NON-MATERIAL AMENDMENT APPLICATION :- 14 Sunnydene Avenue, HA4 6AF

This application seeks consent for non-material amendments to the planning permission 26362/APP/2025/692. These proposed changes are as follows:

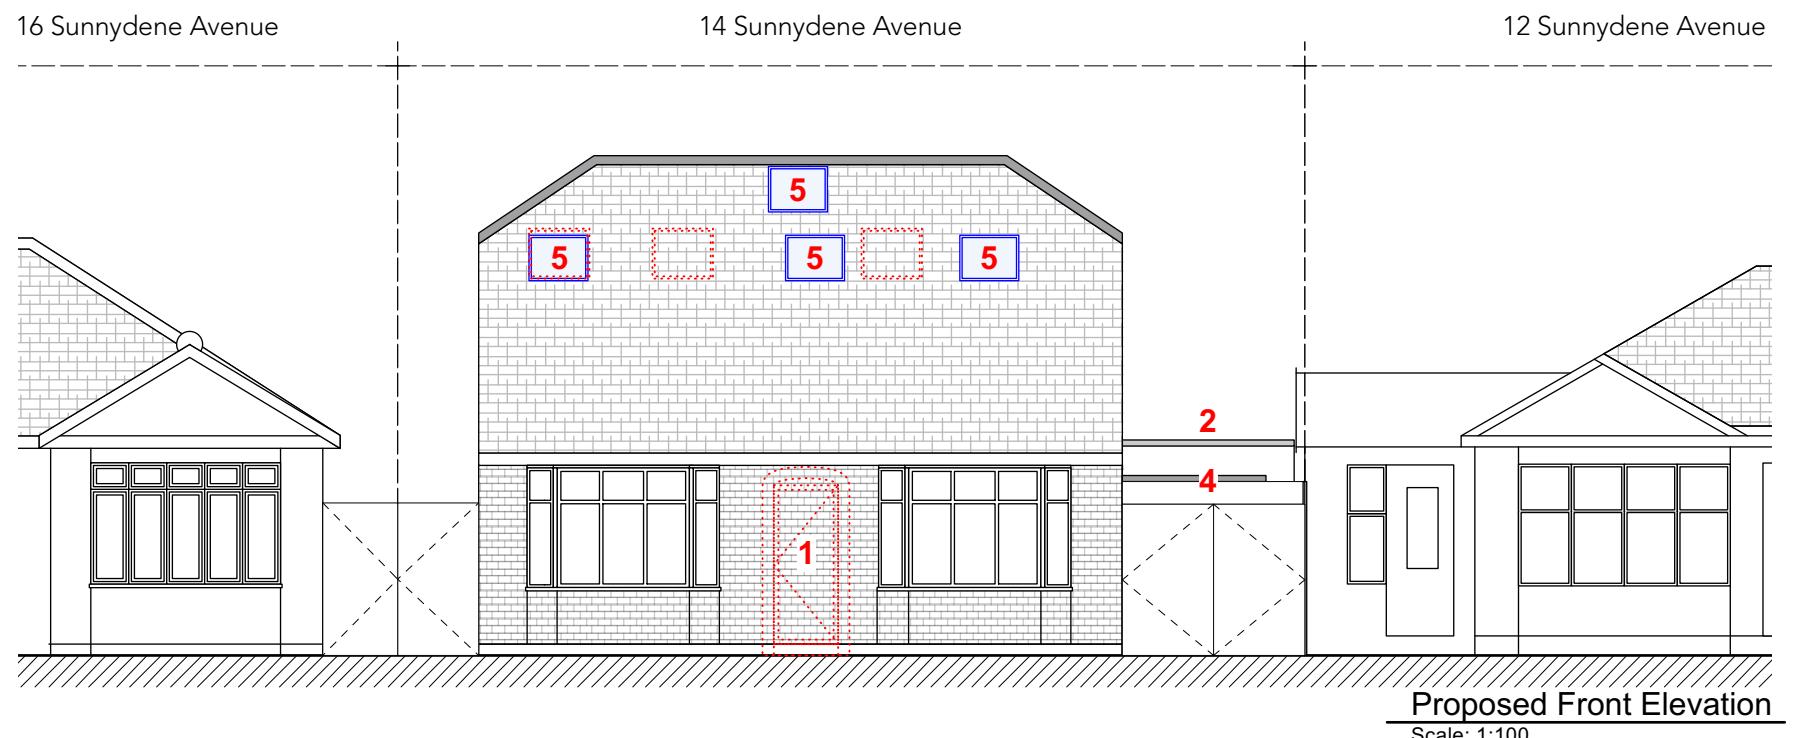
On the ground floor, the existing front entrance is bricked up and replaced by the side entrance. The proposed works will provide a better internal layout and more circulation space for residents. Between No. 12 and 14, a timber porch is proposed to provide entrance to the house, making use of the existing side opening. A new front door and side window is proposed to the porch, finished in timber to match the previously approved side door.

As part of the changes on the ground floor, a utility is proposed replacing the wc, proposed with a side door finished in timber. The side door will provide access to the existing side passage. The door will not be glazed meaning no overlooking issues. x1 Proposed rooflight on the ground floor to the pantry will match the approved ground floor rooflights.

The proposal also seeks permission to amend rooflight locations on the first floor. The proposed rooflight spacing will provide no clashes with walls and are at an appropriate height for comfort. The rooflight approved on the rear roof slope has been moved to the front roof slope in line with the staircase location to provide natural light to this space.

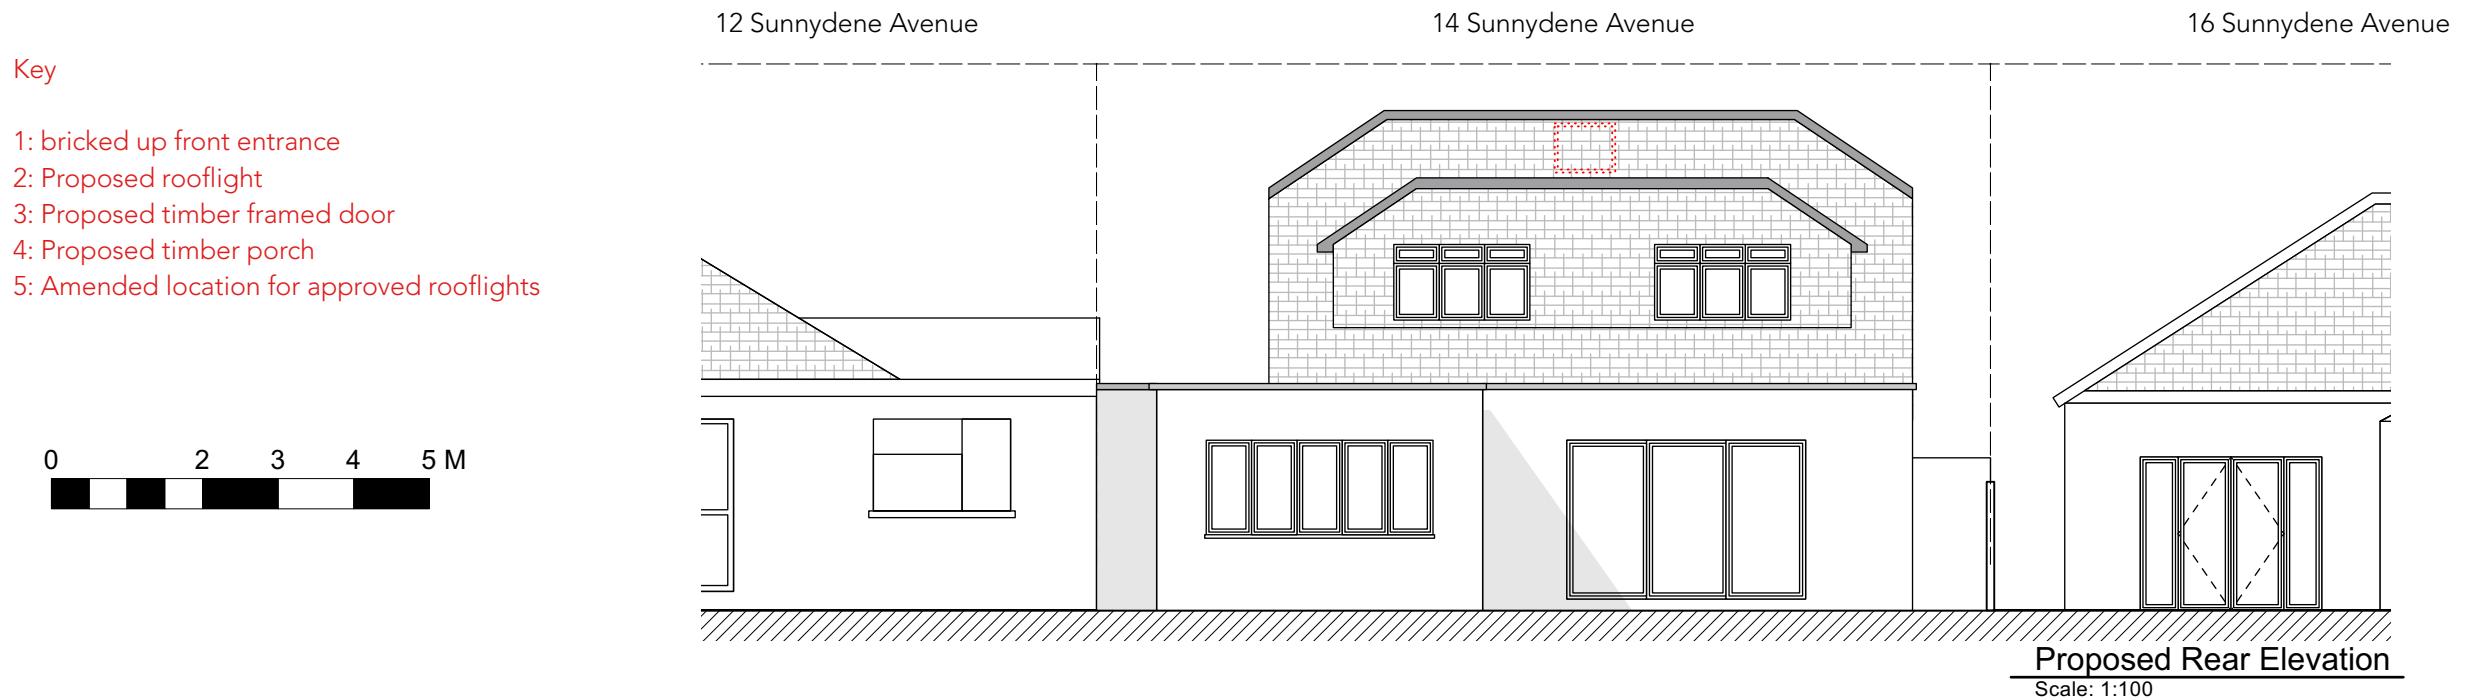
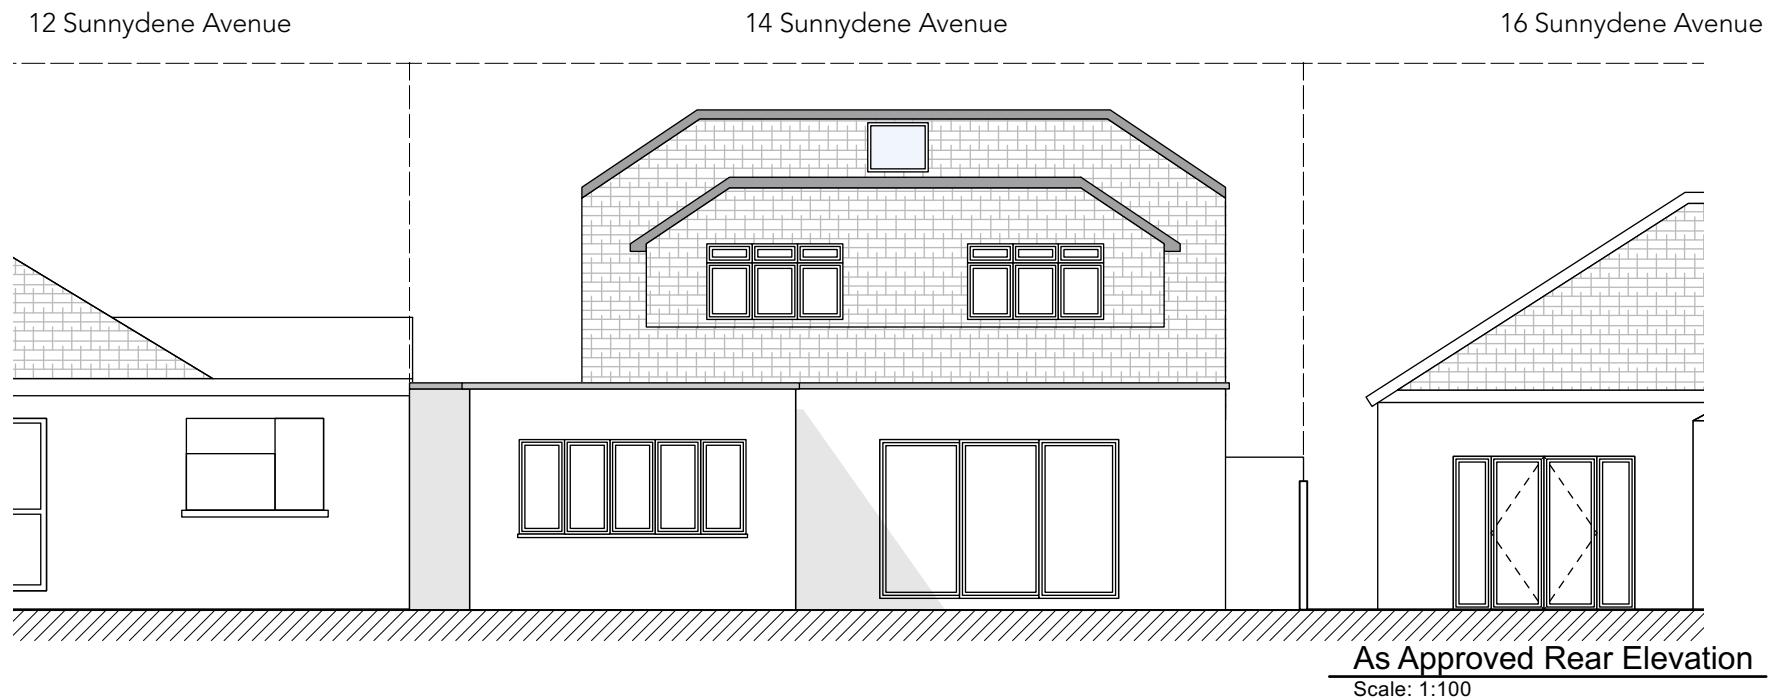
- 1: bricked up front entrance
- 2: Proposed rooflight
- 3: Proposed timber framed door
- 4: Proposed timber porch
- 5: Amended location for approved rooflights

REAR ELEVATIONS: AS APPROVED AND PROPOSED

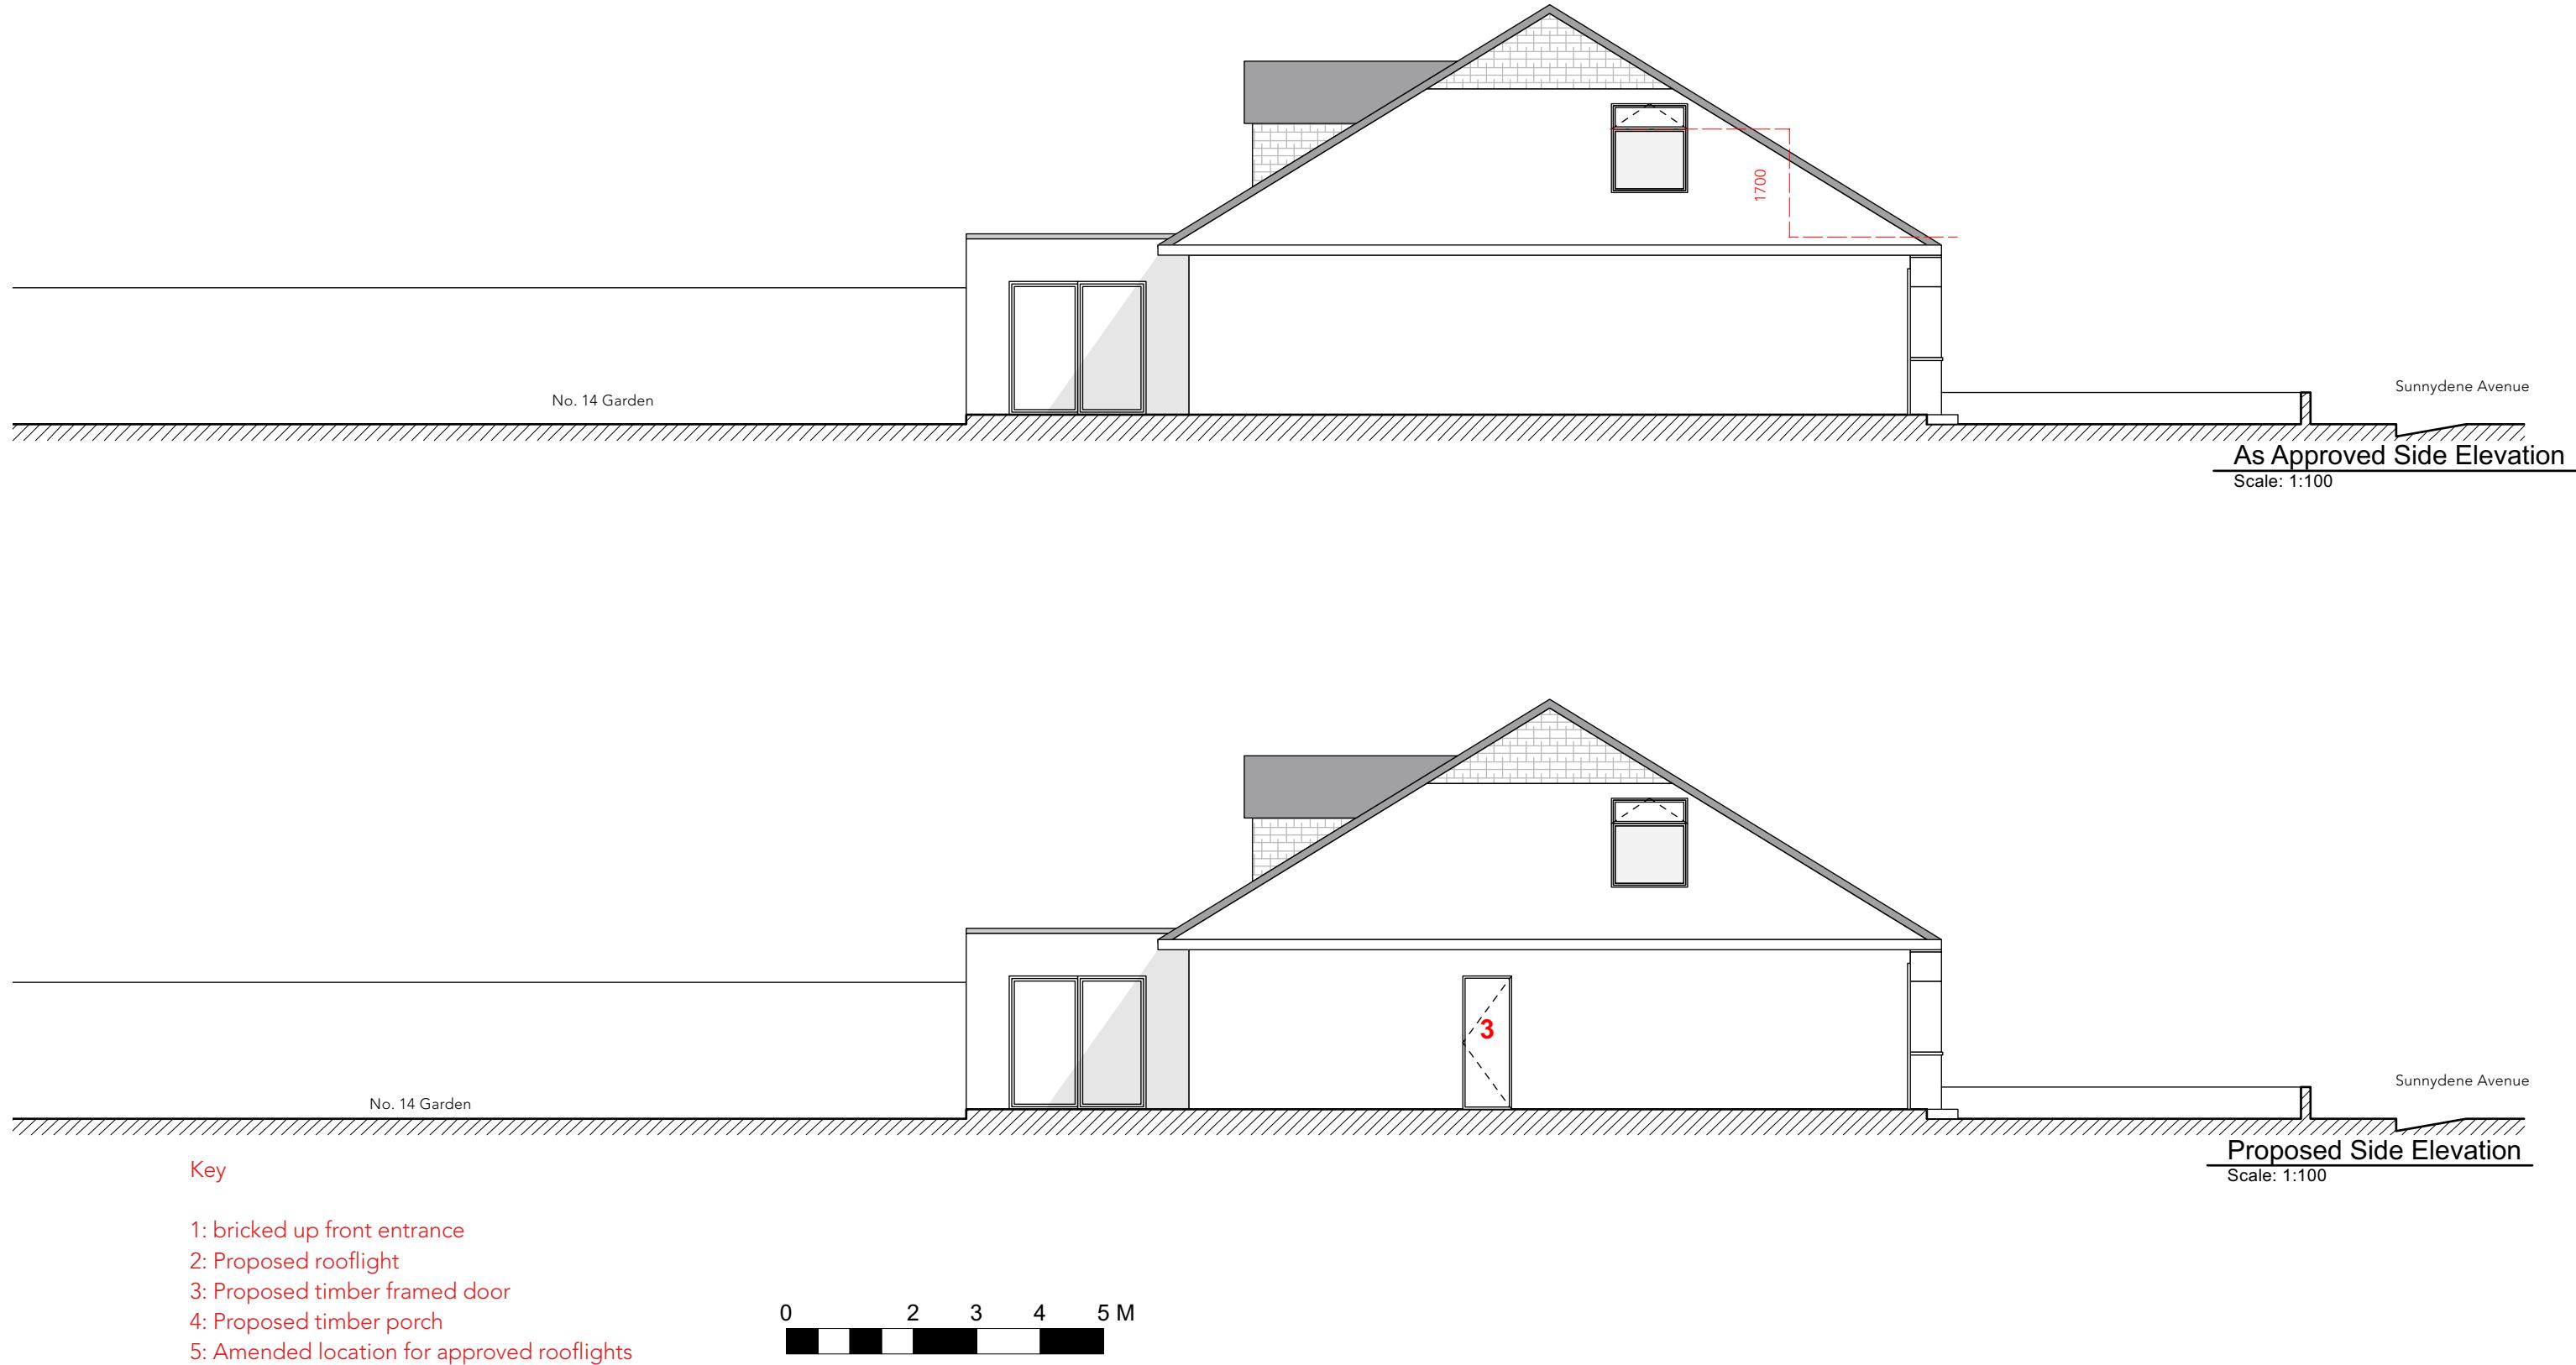
The front elevations opposite show the proposed alterations this application would like to make to the previously approved scheme. The subsequent 3 pages show the side and rear elevation changes that are proposed to this application.
